**Report to the Future Melbourne Committee****Agenda item 6.1****Ministerial Planning Referral: TPM-2022-21  
218-246 Macaulay Road and 23-35 Boundary Road, North Melbourne**

6 February 2024

1. The purpose of this report is to advise the Future Melbourne Committee of a Ministerial Planning Application seeking approval for the development of land at 218-246 Macaulay Road and 23-35 Boundary Road, North Melbourne (refer Attachment 2 – Locality Plan).

Figure 157 - Shadow diagram - 2pm on 21 June

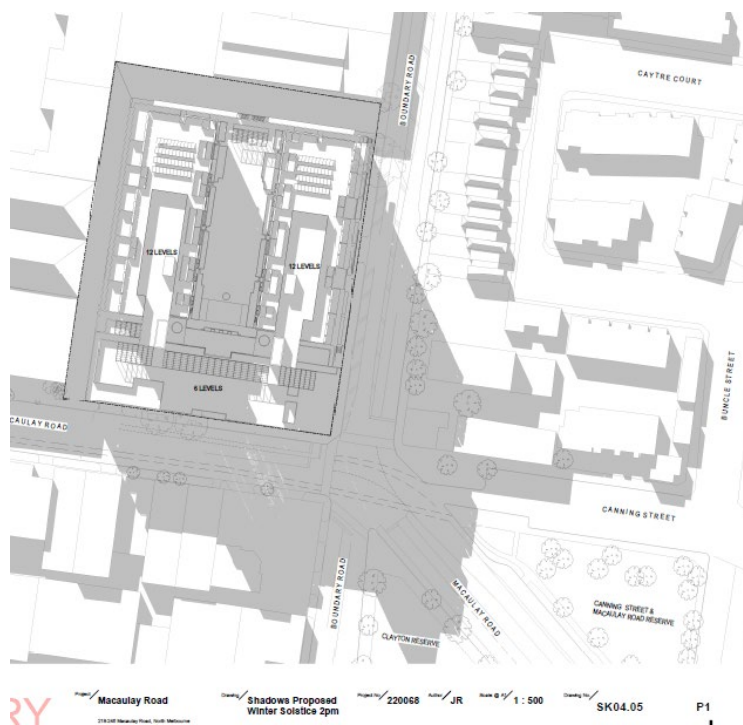
Shadow diagrams provided by the Applicant show that there is shadow to the northernmost portion of Clayton Reserve from 2pm to 3pm on June 21 (winter solstice).

Insufficient information has been provided to determine if the proposal would comply with the requirements of the proposed DDO8 under Amendment C415 as it does not exceed the ‘existing’ or ‘allowable’ shadow cast on Clayton Reserve and Canning Street Reserve on June 21 between 10am and 3pm. The concern is raised insofar that there is likely a need for modifications to the elements above the street wall (setbacks or height reductions) to ensure no additional shadow is cast. A recommended condition will require the provision of updated shadow diagrams with plans submitted for endorsement to ensure this compliance with C415melb – Sunlight to Public Open Spaces is achieved.

NEW STREET (18m)  
 Figure 16 - New Street (18m) Section

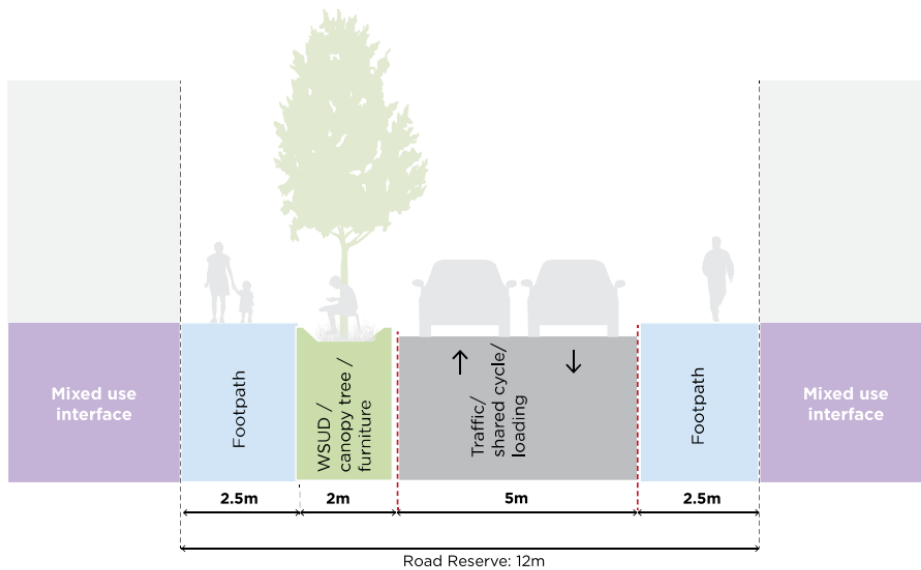
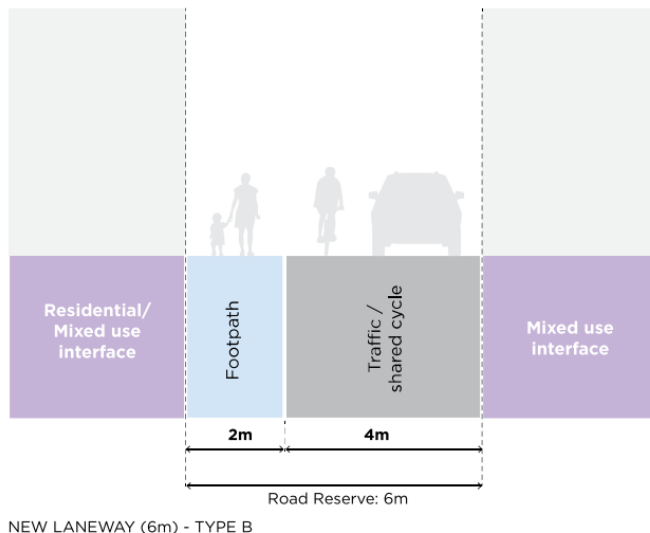
As noted in Section 6.3.1 of this report, C417 seeks to have a new 18 metre wide street located entirely along the north boundary of the site and a 12 metre wide street provided along the west boundary of the site. The cross sections of the streets, as contained in the "Incorporated Document "Macaulay – Stubbs and Boundary Precincts – New and Widened Streets and Laneways – Alignments and Cross-Sections, June 2022" are provided in Figure 19 and 20.

- A 9 metre wide link along the northern property boundary, consisting of:
  - 2 metre wide footpath (impeded by structure columns)
  - 1.3 metre landscaping
  - 5.8 metre wide link for vehicles.
- A 6 metre wide link along the western property boundary, consisting of:
  - Partial 2 metre wide footpath
  - 4.35 metre wide link for vehicles.

The proposed link composition does not directly align with the street and laneway typologies sought by C417. The proposed north boundary link is akin more so to the 'New Street 12m', as shown in Figure 20. This would mean that when the neighbouring properties to the north are developed, to complete the 'street', a footpath of at least 2.5 metres would be required.

Figure 182 - 'Type 1D' 1 Bedroom Apartment layout.

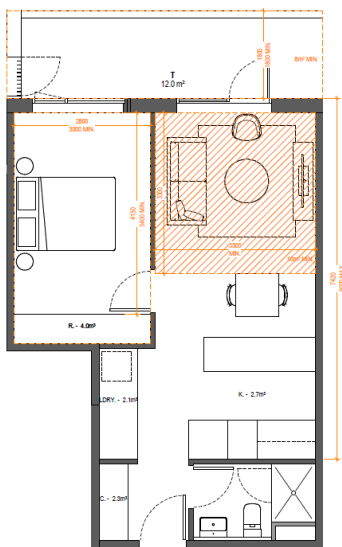
Dwelling type 1D fails to meet the minimum dimension requirements by providing a bedroom that is 2.8 metres x 4.15 metres whereby the minimum width is 3 metres (a 0.2 metre variation). Dwelling type 1D is proposed to occur in two instances across the entirety of the development. In this instance the variation is considered acceptable on the basis that they are of low occurrence and an addition 0.75 metre in depth is provided – ensuring the room remains functional.
